Objection to Policy E2

Flawed reasoning for de-allocation

PROJECT TITLE	HAYLING FARM BRIDGE STR: E15/37 ELR: SDP1 MILEAGE: 11.0041
DRAWING TITLE	LOW LEVEL BRIDGE PLAN SHOWING PROPOSED ROAD ARRANGEMENT AND SECTIONS

Hayling Farm Underbridge

Page 1 of 2	Document Review Notice (DRN)				
	Form Ref	NR/L2/INI/02009/F0044	Issue Date	05/09/2015	Issue

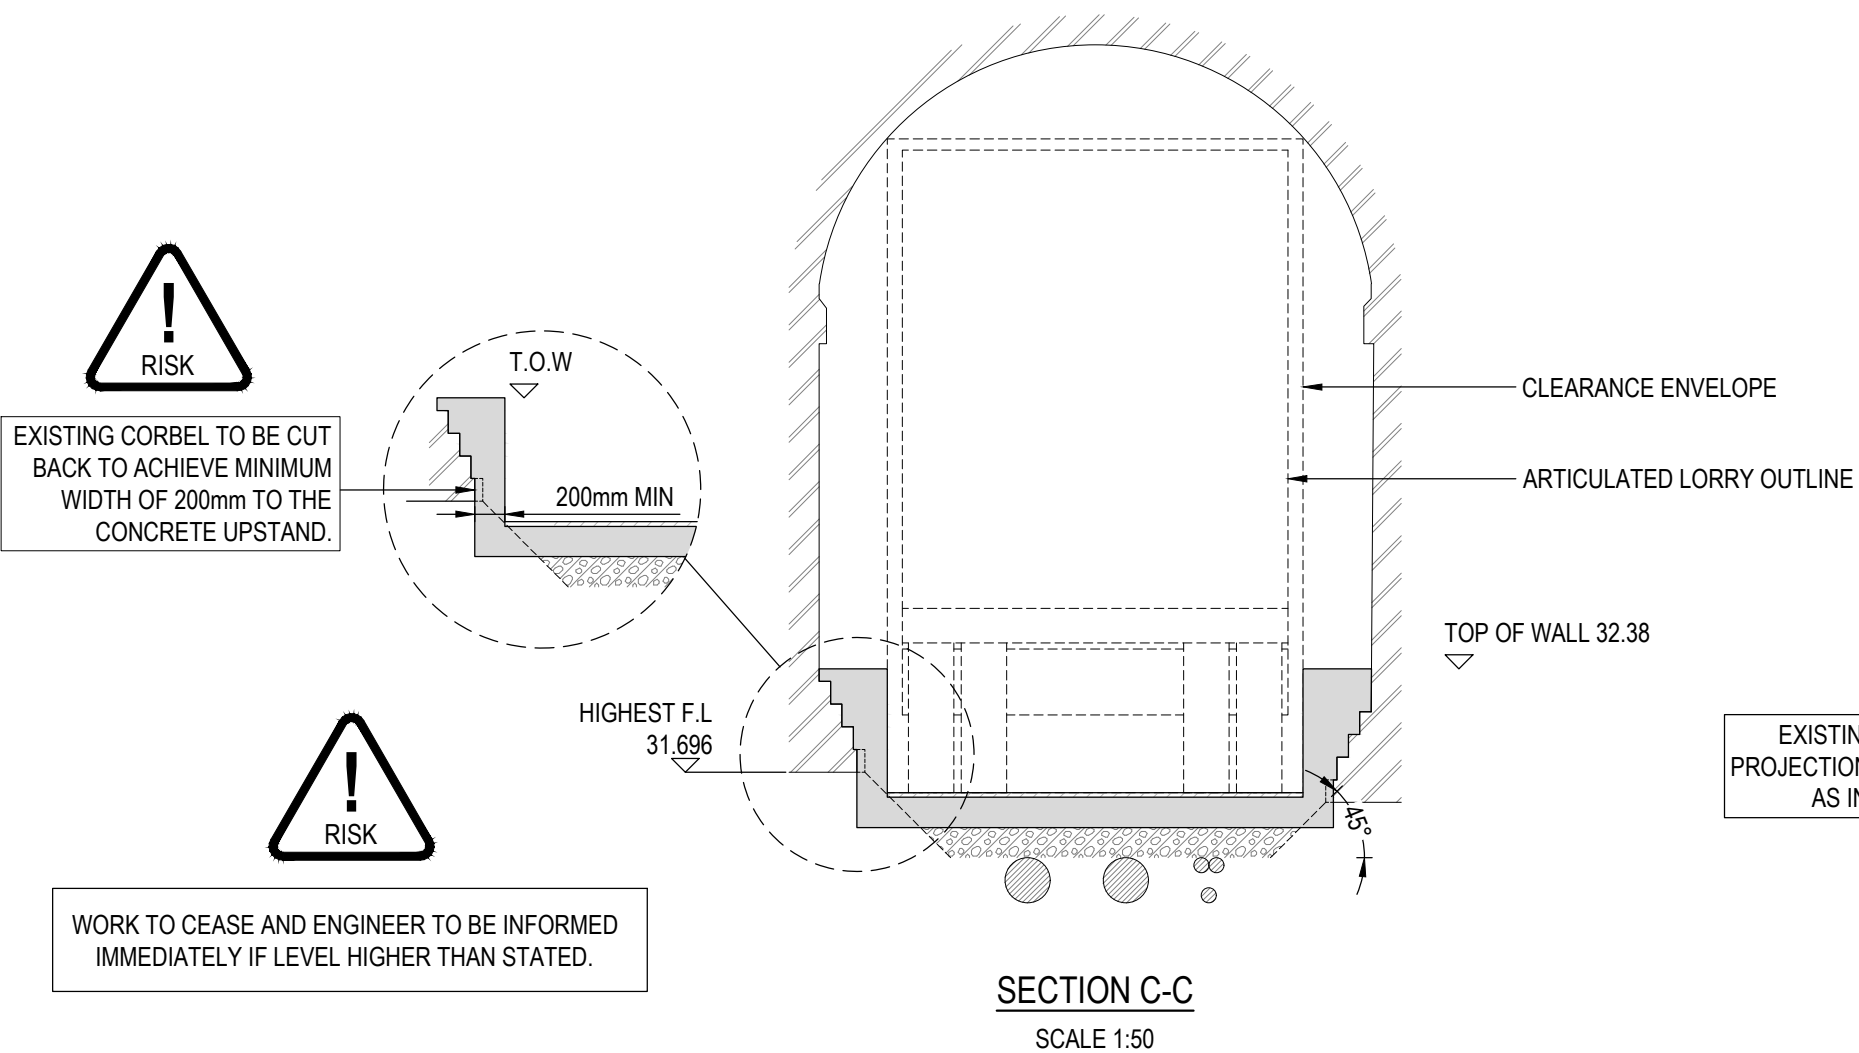
Page 2 of 2		Document Review Notice (DRN)				DRN No: WE1151	
Form Reference		NR/L2/INI/02009/F0044		Issue Date	05/09/2015	Issue	8.0
Network Rail (NR)		Supplier				NR	
No	Comments	By	Type	Integration Activity	Comment Accepted	Responses	By
1	Google streetview shows a wide crack in intrados approximately 1m from North West corner. An investigation should be undertaken to assess cause of cracking. Also any other defects present on the bridge should also be identified. Remedial works to the defects identified should be undertaken prior to main works.	AB	3A				
2	Monitoring of the underbridge should be undertaken during construction. The monitoring should be taken on a regular basis, even during night time, preferably using a remote equipment.	AB	2A				
3	The risk assessment did not include the risk of the abutment foundations moving together as a result of the removal of passive restraint. This needs to be addressed with adequate mitigation.	AB	3A

4	A method statement will be required before the work is undertaken. We would expect emergency propping equipment to be available on site in case any movement was detected in the abutments.	AB	4				
5							
6							
7
